## OBJECTION TO GRANT OF PLANNING PERMIT

What is the permit application number?	TP- 2016-1047 .....
What is the address of the land?	121 – 131 Cardigan Street Carlton .....

View of new Development from the North [Image extracted from Application]

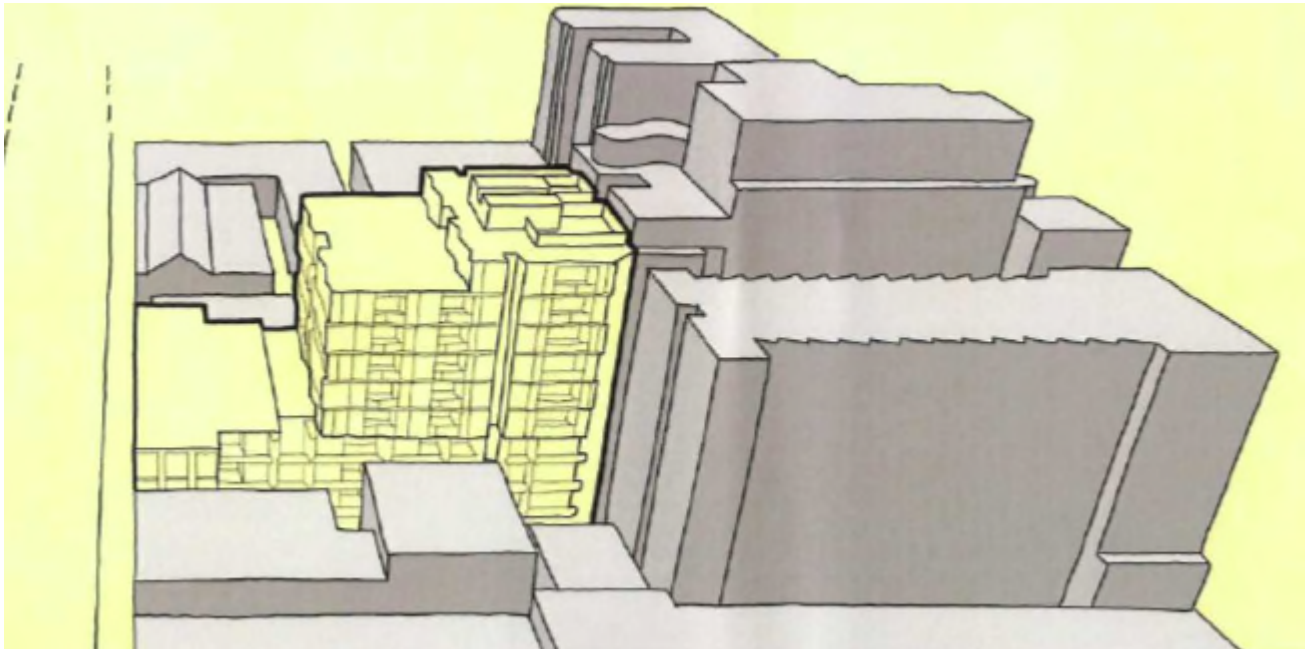
While the CRA welcomes the lower scale of development on the Cardigan Street frontage [at 4 levels] we submit that the 10 level rear section should be moderated. We are also of the view that solar access to the lower level south facing private open spaces is poor, and should be compensated by providing use of the roof space for shared open space.

The key planning control is the DDO 47, which has a recommended [but discretionary] building height of 4 storeys. We note that a principal Objective of this DDO is to "maintain the predominant low scale nature of the area." At 10 levels, the rear section of the development would establish a "mid-rise scale of buildings (6 to 15 storeys)" a level of intensity that is intended for the City North Capital City Zone. At 10 levels, the proposal would also exceed the recommended maximum height for those developments facing Swanston Street [of 9 levels – DDO 45].

While we are aware that taller buildings have been approved in the Pelham Street area of DDO 47, we do not accept that these buildings should provide a relevant benchmark for an area intended to be low scale in nature. If Planning Authorities believe that the intended low scale of DDO 47 is no longer relevant or appropriate, the Planning Scheme should be amended. In our view, there are many other sites in the Carlton area where more intense developments could be located.

We accept that the shadow analysis provided by the Applicant demonstrates that much lower buildings, including a 6 level residential building, would still cast a shadow over the roofs of the dwellings on the South side of Kelvin Place. However, in our view a building of this lower scale, would provide a much better quality of pedestrian amenity for both Kelvin Place and Levers Terrace, the second key Objective of DDO 47.
